CERTIFICATE OF APPROPRIATENESS

Property: 7707 Lakewind Street, tract 35, block 21, Glenbrook Valley Subdivision. The property includes a historic 3,469 square foot, one-story wood frame single-family residence and an attached garage situated on a 35,524 square foot interior lot.

Proposal: Alteration – Window Replacement

WEST SIDE ELEVATION

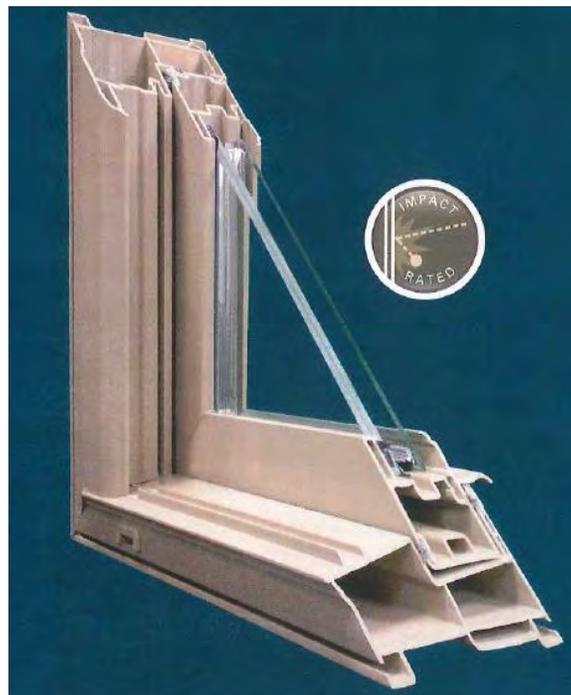
Window 10: Existing first floor aluminum 6-over-6 single hung window to be replaced with a vinyl 1-over-1 single hung window.

Window 11: Existing first floor aluminum 6-over-6 single hung window to be replaced with a vinyl single hung window.
